SUBDIVISION REVIEW SHEET

CASE NO.: C8J-2021-0080.0A

SUBDIVISION NAME: Hidden Oaks Estates Subdivision

**CITY OF AUSTIN – TRAVIS COUNTY – SINGLE SUBDIVISION OFFICE
SUBDIVISION APPLICATION – MASTER COMMENT REPORT**

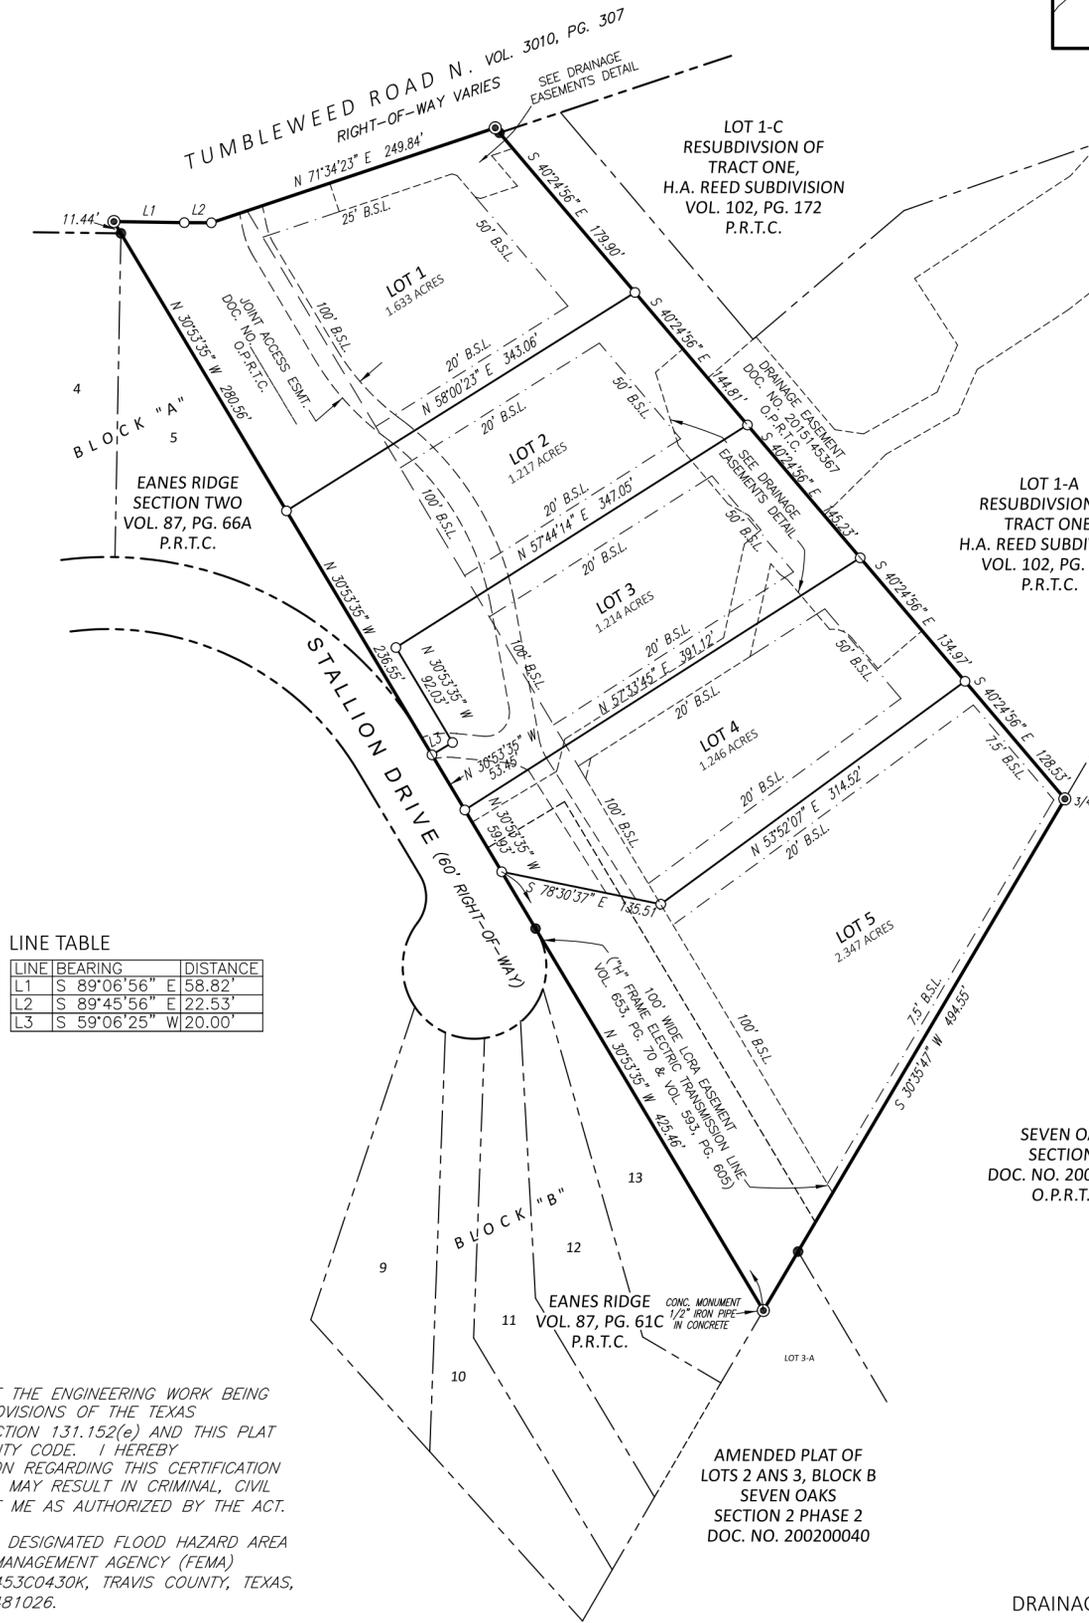
Ten-foot electric telecommunications is required along the rear property line. Show the easement(s) on the face of the plat.

AD2: Please update label for N TUMBLEWEED TRL it is incorrect in your layout

EV 2 Provided that the point of access is not required by the fire department or emergency responders, shift the driveway alignment on lots 1 and 2 to avoid slopes over 15%.

- SR 2. Please ensure that everything that is referenced in the legend is also shown on the face of the plat and vice versa, including all acronyms and symbols. (LDC § 30-1-113)

- SR 5. Remove the building setback lines from the face of the plat, as there is no zoning in the ETJ. These can be included in the covenants and restrictions and privately enforced if desired. (LDC § 30-1-113)

SR 13. Remove Plat Note 4 (there is no zoning in the ETJ or enforced by Travis County) and Note 14
(there are no commercial or industrial lots). (LDC § 30-1-113)

DRAINAGE EASEMENTS DETAIL
1 INCH = 200 FEET

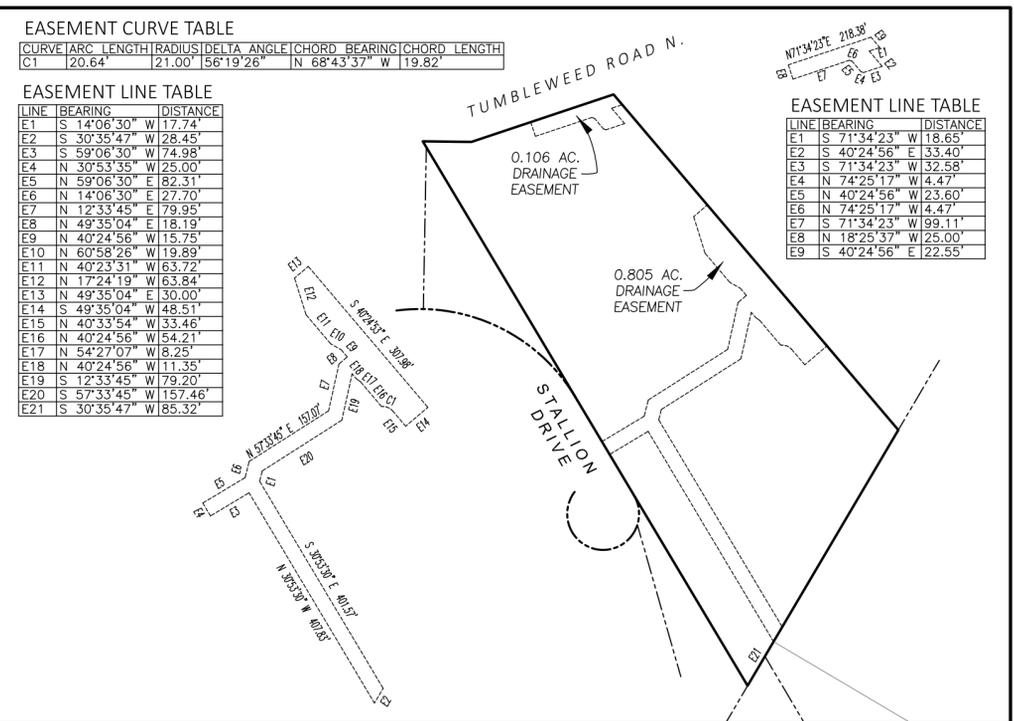
EL 2. Please contact electric designer Donathan Hutchinson at Donathan.Hutchinson@austinenergy.com to discuss drainage easement and potential pond.
